SERVICE INSTRUCTION

Introduction of new double ignition coils and new wiring harnesses for ROTAX® Engine Type 912 i (Series), 915 i (Series) and 916 i (Series)

ATA System: 74-20-00 Ignition system

Fig. 1

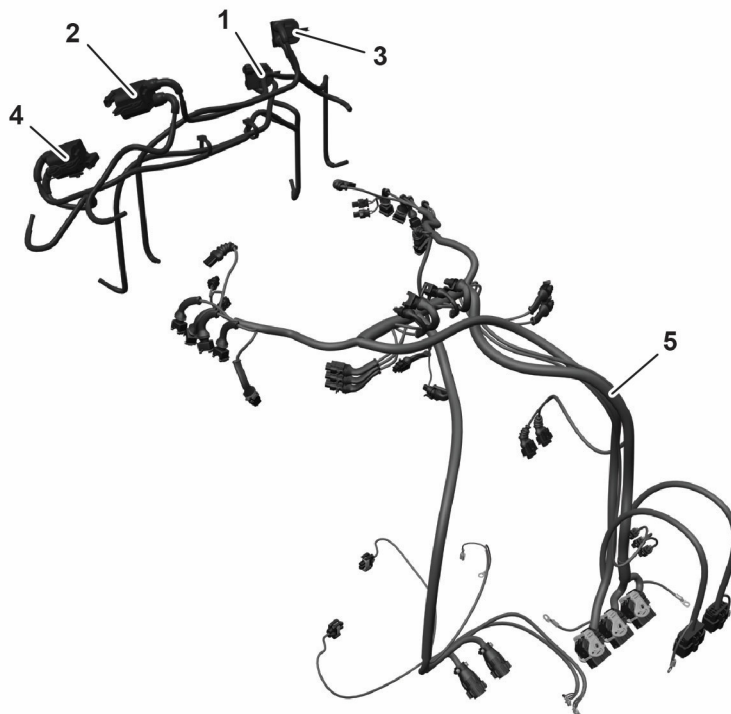
In the course of further development and standardization, the power connectors on double ignition coils have been changed from two individual Faston connectors to a single sealed Tyco connector. In addition, the wiring harness has been changed to accommodate the new Tyco connectors at each double ignition coil.

Fig.no.	Part no.	Qty/engine	Description	Application
1-1	864660	(1)	DOUBLE IGNITION COIL 1 ASSY.	Spark plugs 1B, 2B
1-2	864661	(1)	DOUBLE IGNITION COIL 2 ASSY.	Spark plugs 1T, 2T
1-3	864662	(1)	DOUBLE IGNITION COIL 3 ASSY.	Spark plugs 3B, 4B
1-4	864663	(1)	DOUBLE IGNITION COIL 4 ASSY.	Spark plugs 3T, 4T
1-5	665621	(1)	WIRING HARNESS STANDARD	912 i Series
1-5	665623	(1)	WIRING HARNESS SHORT	912 i Series
1-5	665622	(1)	WIRING HARNESS SPECIAL	912 i Series
1-5	665681	(1)	WIRING HARNESS STANDARD	915 i A Series
1-5	665688	(1)	WIRING HARNESS STANDARD	915 i C24 Series
1-5	665683	(1)	WIRING HARNESS SHORT	915 i C24 Series
1-5	665681	(1)	WIRING HARNESS STANDARD	916 i A Series
1-5	665685	(1)	WIRING HARNESS STANDARD	916 iSc B
